Federal Register

Wednesday, January 25, 2012

10 CFR Part 430

Energy Conservation Program for Consumer Products: Test Procedures for Refrigerators, Refrigerator-Freezers, and Freezers

Figure 1

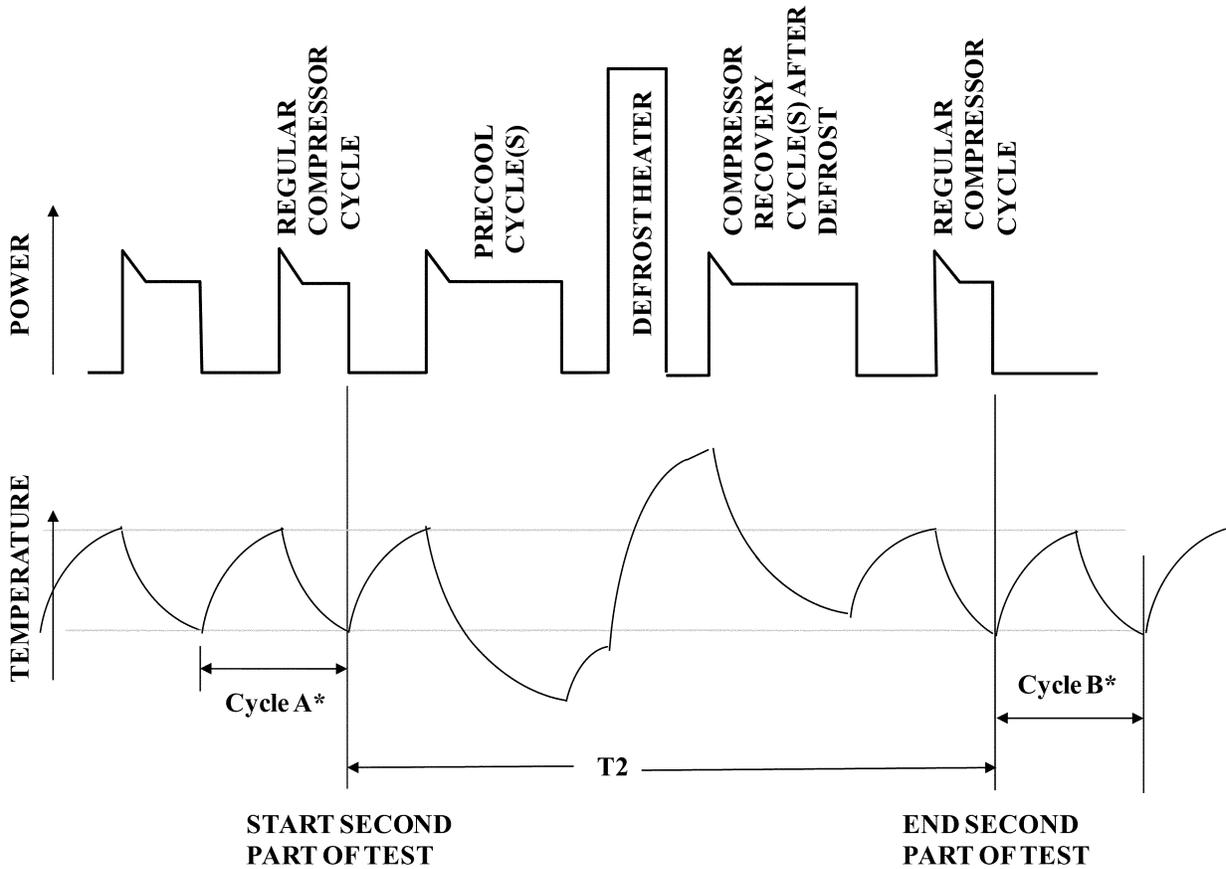
Part of the justification for modifying the test procedure in the manner suggested by Whirlpool is based on the observation that when using the test period prescribed by the interim final rule, the average compartment temperature would be warmer at the end of the test period than at its start for a system with a cycling compressor. The interim final rule test procedure includes a provision to verify that the product does not employ partial recovery. Using this provision requires examining the full compressor cycle immediately after the test period to ensure that it is a regular compressor cycle, *i.e.* a compressor cycle associated with steady state operation. However, the test does not account for the additional temperature recovery associated with a regular compressor “on” cycle. The December 2010 notice indicates that the test period T2 starts when the compartment is at its typical minimum temperature associated with steady state cycling operation. This minimum temperature is represented by the lower horizontal line of the temperature plot in Figure 1 of Appendix A. 75 FR at 78855 (Dec. 16, 2010) (*see* temperature plot of Figure 1, “Long-time Automatic Defrost Diagram for Cycling Compressors”).

On the other hand, the compartment temperature is at its typical steady-state cycling maximum (the higher horizontal line of the temperature plot) when test period T2 ends. Hence, while the compartment temperature has recovered to the range within which it varies during steady state operation, it has not recovered to the temperature state associated with the start of the test period—*i.e.* the temperature is warmer than at the start of the test period. In order to allow recovery to the start-of-test-period temperature, the test period would have to continue till the end of the compressor “on” cycle. These

- a. Revising section 4.2.1.1, including figure 1;
- b. Revising section 4.2.1.2, including figure 2;
- c. Revising 4.2.4; and
- d. Revising sections 5.2.1.3 and 5.2.1.5.

°C) of their average temperatures measured for the first part of the test. See Figure 1.

***Average compartment temperature(s) during cycles A & B must be within 0.5 °F of the average temperature(s) for the first part of the test.**

Figure 2

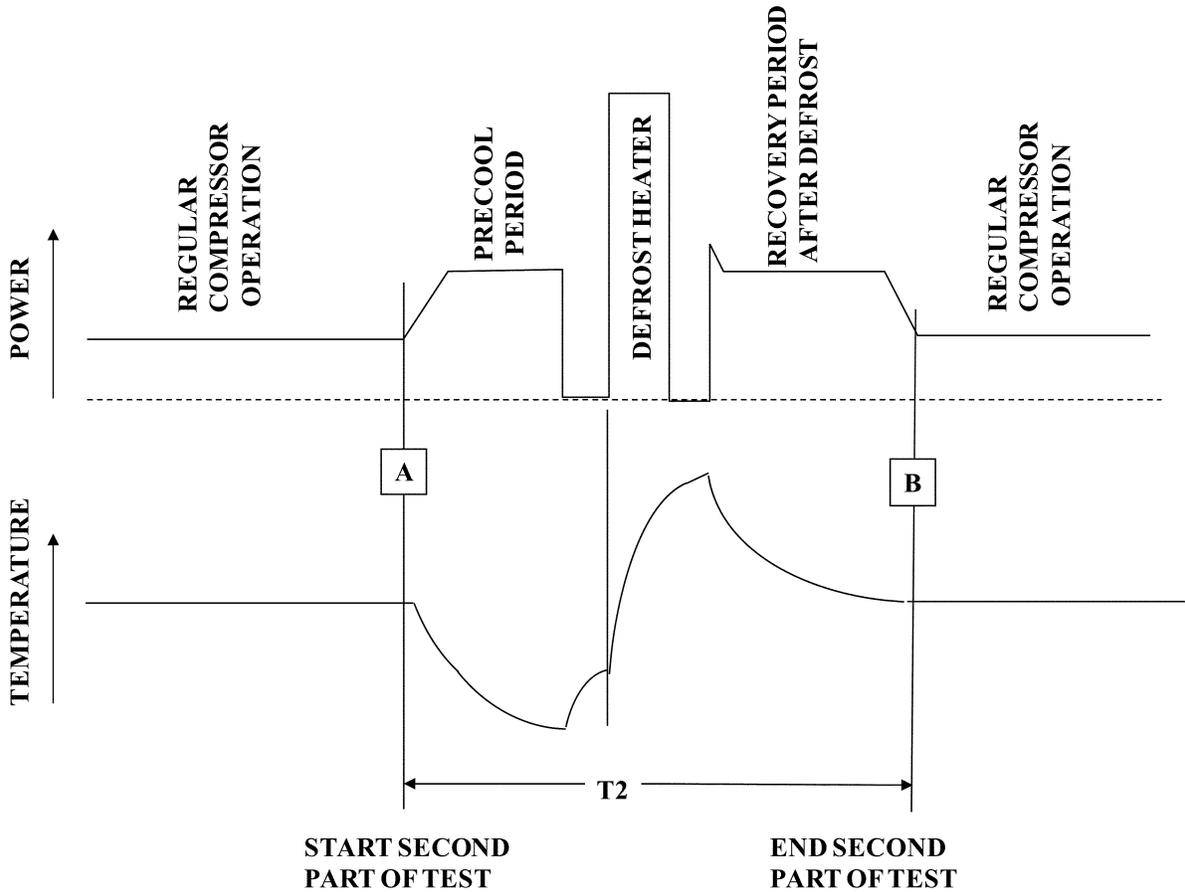
The interim final rule includes a figure for both Appendices A and B that illustrates the second part of the test for products with non-cycling compressors. That figure, Figure 2, includes two horizontal lines in the temperature plot that have no meaning. In this final rule, these lines of Figure 2 have been removed. DOE is making this change to avoid confusion and to ensure the accuracy of the measured test results. This amendment represents no change to the specified test procedure.

temperatures of both compartments are within 0.5 °F (0.3 °C) of their average temperatures measured for the first part of the test. See Figure 2.

*Average compartment temperature(s) at times A & B must be within 0.5 °F of the average temperature(s) for the first part of the test.

Figure 1

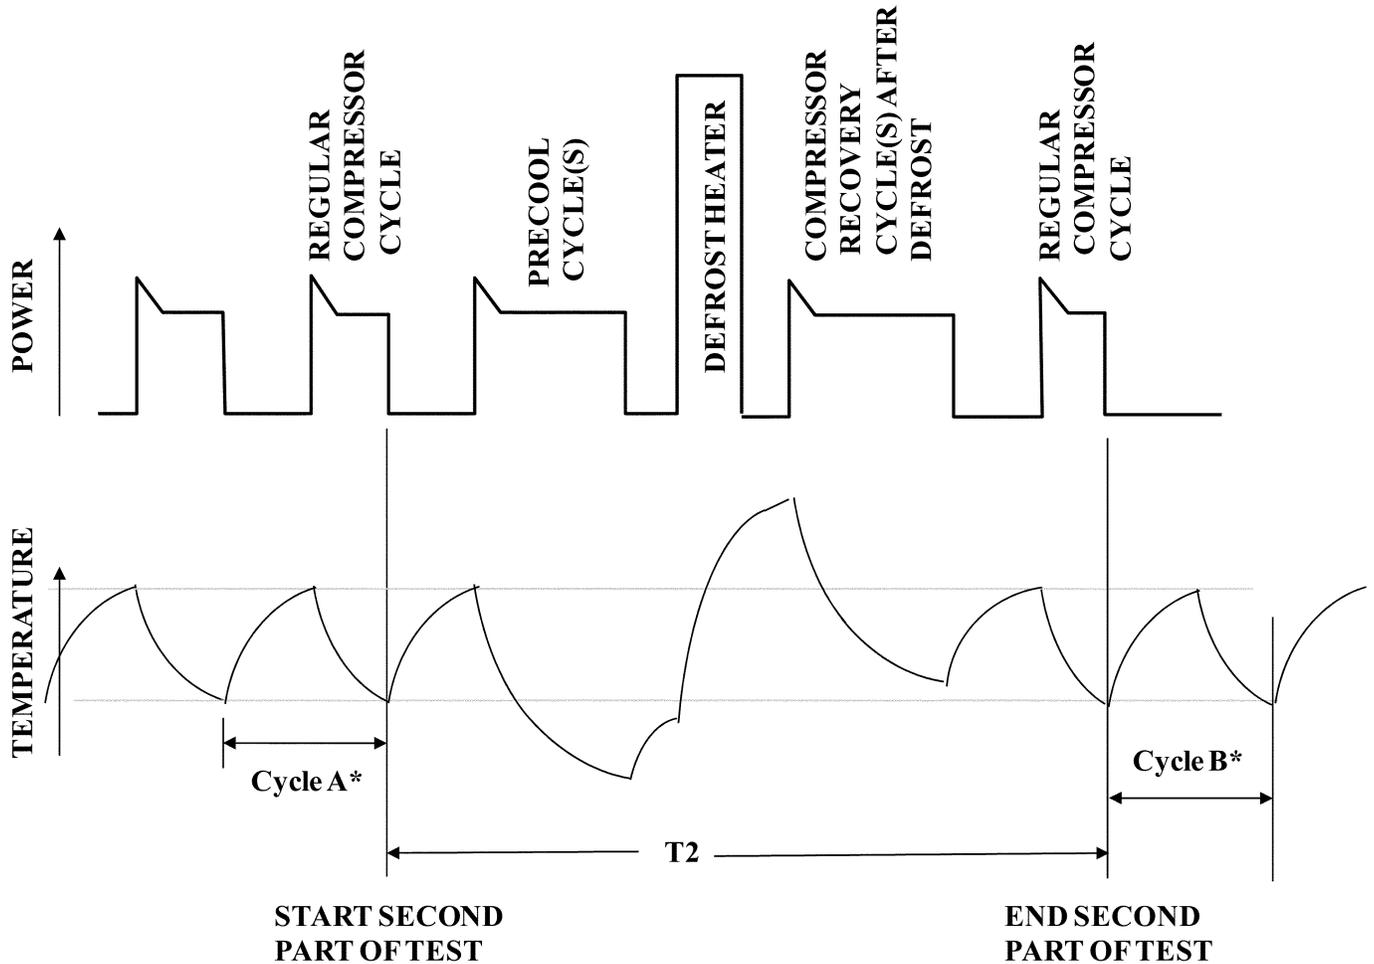
■ a. Revising section 4.2.1.1 including figure 1;

part of the test starts at the termination of the last regular compressor “on” cycle. The average temperature of the compartment measured from the termination of the previous compressor “on” cycle to the termination of the last regular compressor “on” cycle must be within 0.5 °F (0.3 °C) of the average temperature of the compartment measured for the first part of the test. If any compressor cycles occur prior to the defrost heater being energized that cause the average temperature in the compartment to deviate from the average temperature for the first part of the test by more than 0.5 °F (0.3 °C), these compressor cycles are not considered regular compressor cycles and must be included in the second part of the test. As an example, a “precooling” cycle, which is an extended compressor cycle that lowers the compartment temperature prior to energizing the defrost heater, must be included in the second part of the test. The test period for the second part of the test ends at the termination of the first regular compressor “on” cycle after the compartment temperatures have fully recovered to their stable conditions. The average temperature of the compartment measured from this termination of the first regular compressor “on” cycle until the termination of the next regular compressor “on” cycle must be within 0.5 °F (0.3 °C) of the average temperature of the compartment measured for the first part of the test. See Figure 1.

***Average compartment temperature during cycles A & B must be within 0.5 °F of the average temperature for the first part of the test.**

Figure 2

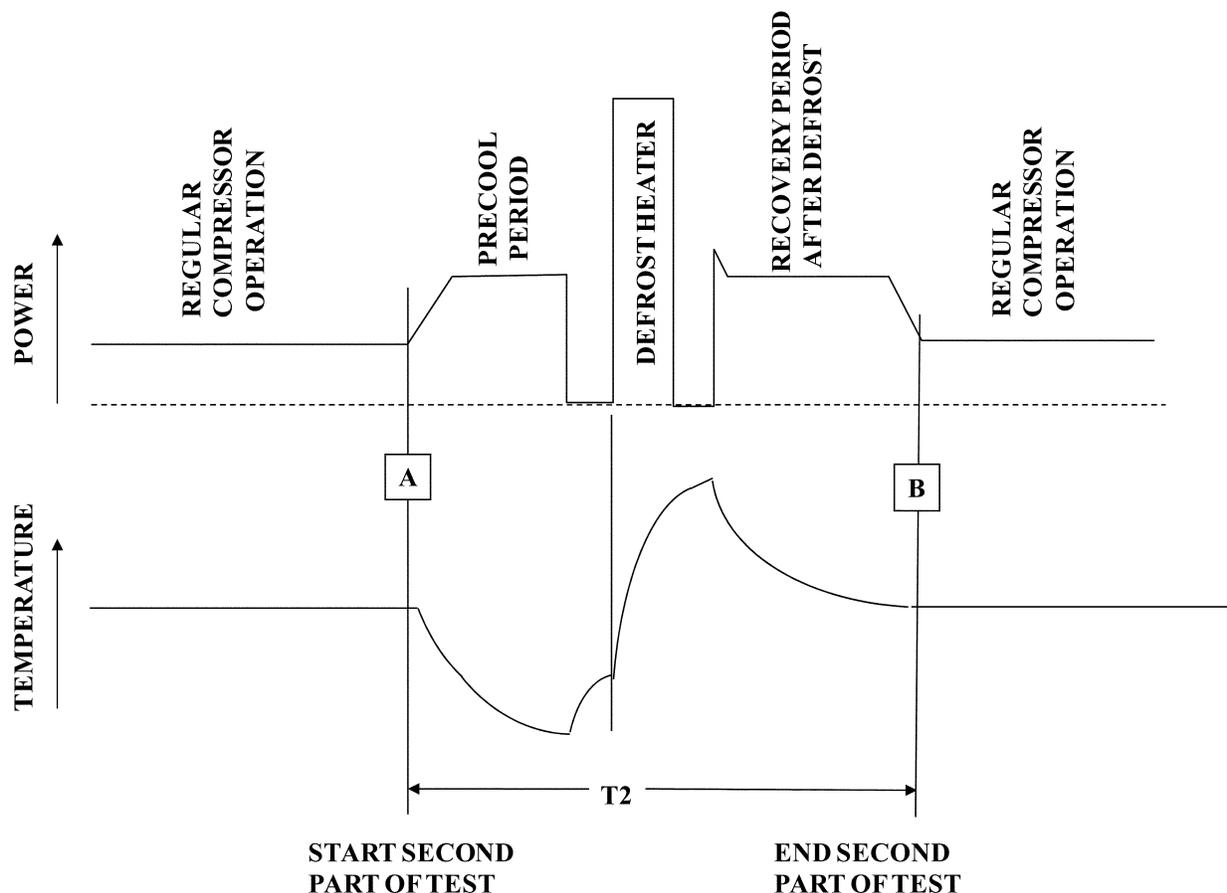
■ b. Revising section 4.2.1.2, including figure 2; and

(0.3 °C) of the average temperature of the compartment measured for the first part of the test. See Figure 2.

*Average compartment temperature at times A & B must be within 0.5 °F of the average temperature for the first part of the test.
